Platform A1 - Booth area  
Previous comments are  
still valid, see following  
slides

Important: the 12 columns of the Spray Booth have been modified after change of the Scrubber technology by Renault-VAZ

Axes 5/023

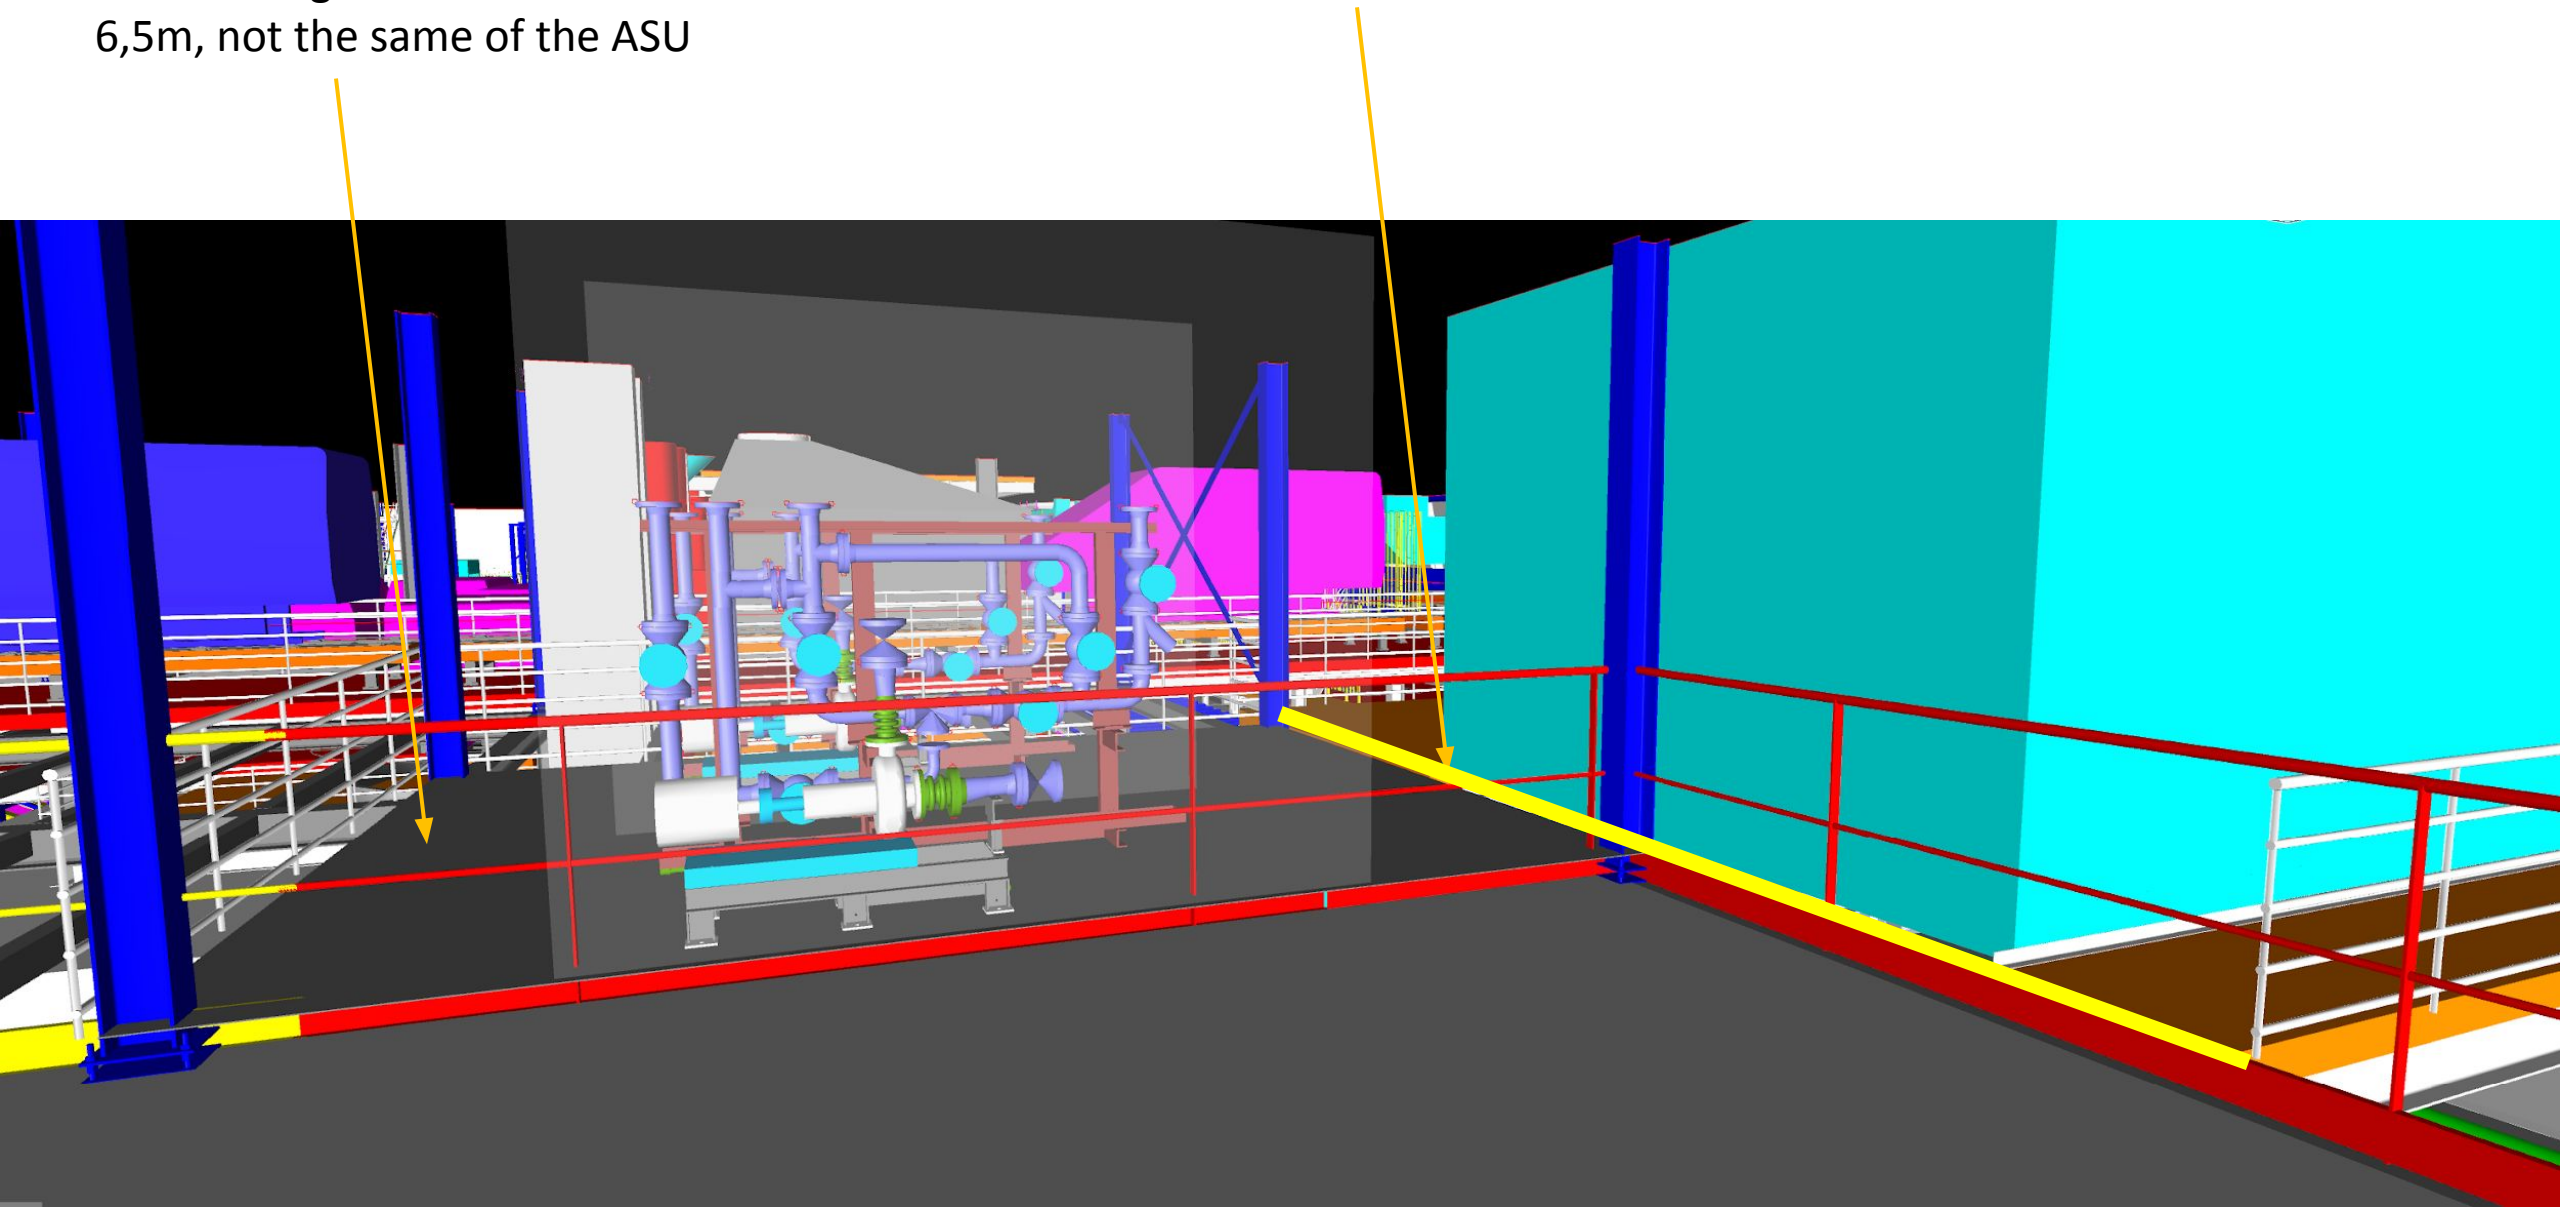
Move monorail columns 350mm left according to last gen. Layout (04/05) Otherwise ASU doors won't open correctly

Axes 8/023

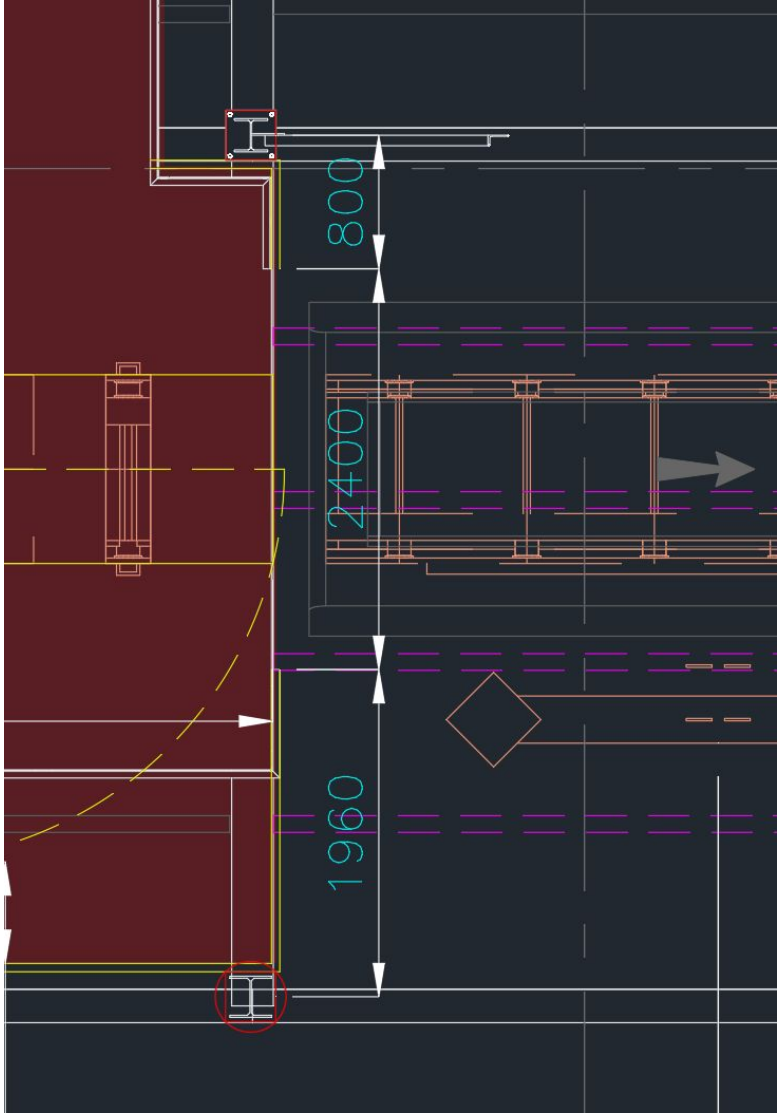
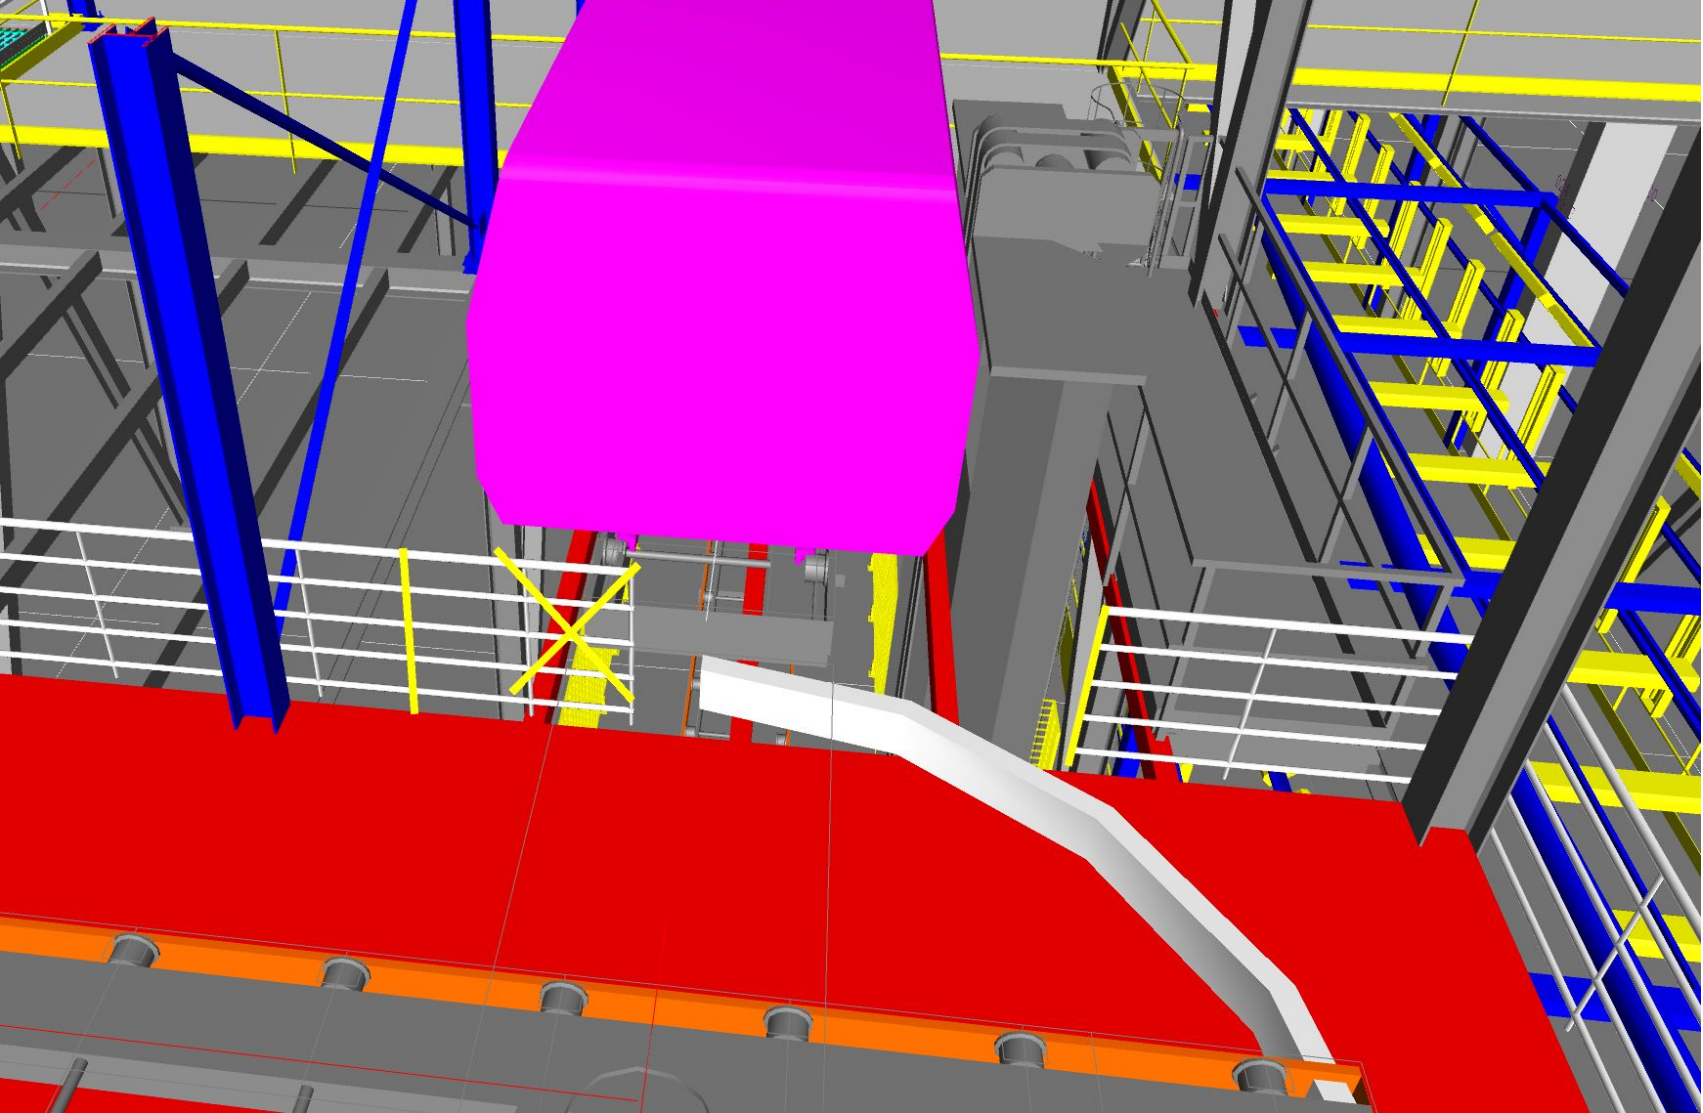
This walking level should be at elev.  
6,5m, not the same of the ASU

We will have a step along this line

Platform B – (022/10-11): adjust handrail according to Layout dimensions (right picture)

Move monorail from  
0,00 to 4,65 (platf.  
A1)

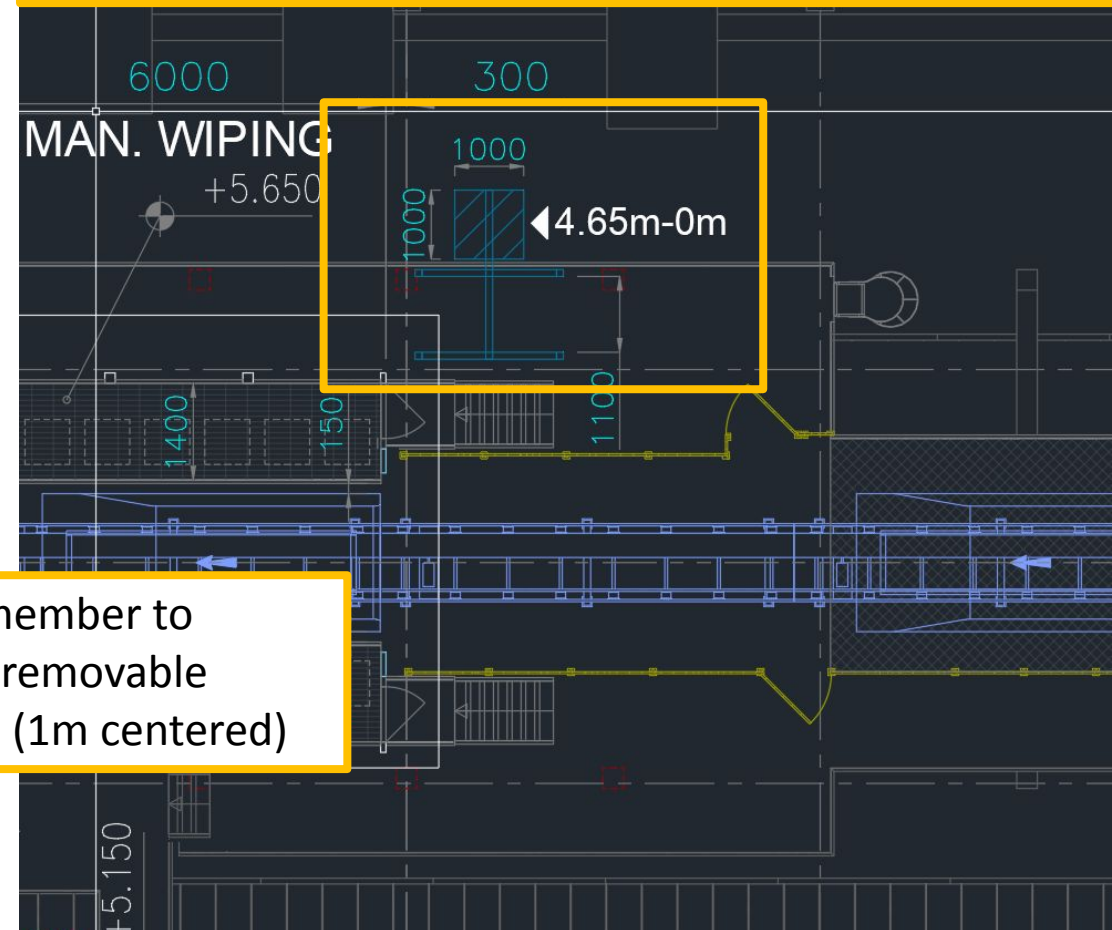
Looks like you used same monorail of ASU, this should  
be smaller, it downloads only the empty filters of the  
Drypan

Axes 6/016  
Axes 7/016

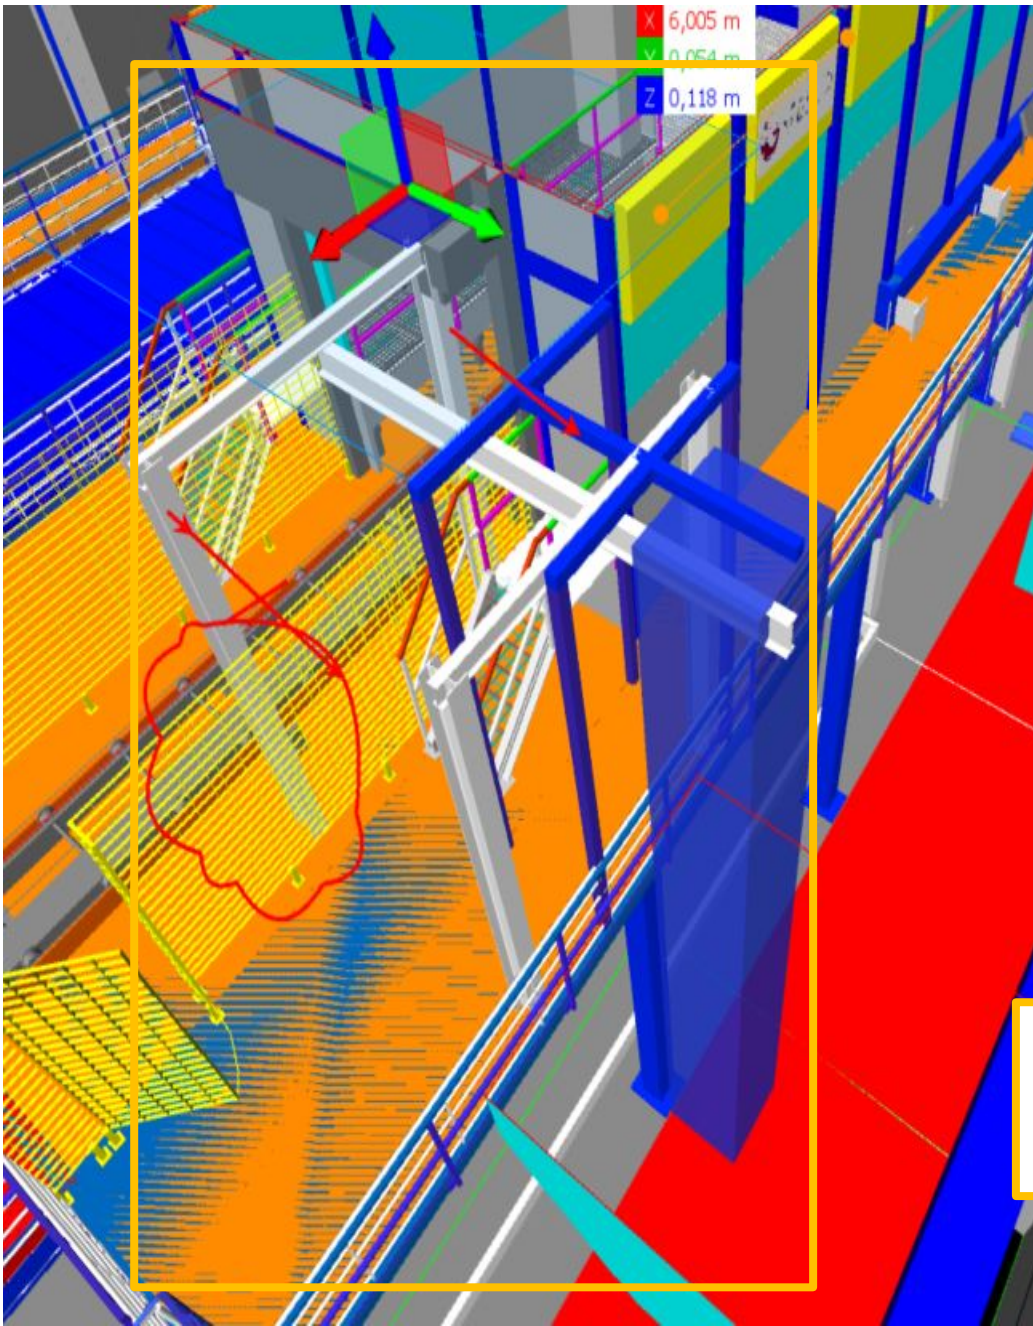
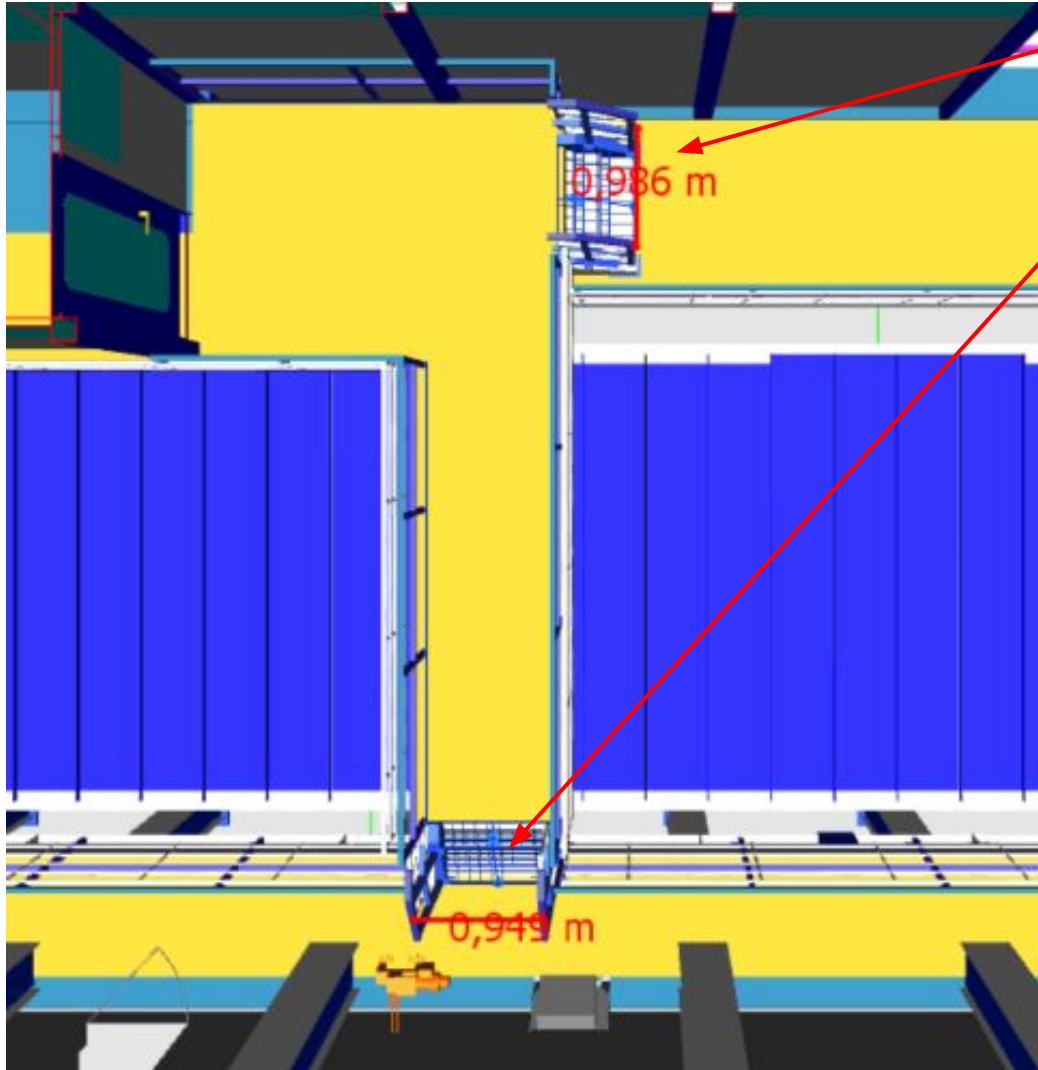
Also remember to  
provide removable  
handrail (1m centered)

Stairs to be minimum 1 meter for safety evacuation (net dimension between handrails)
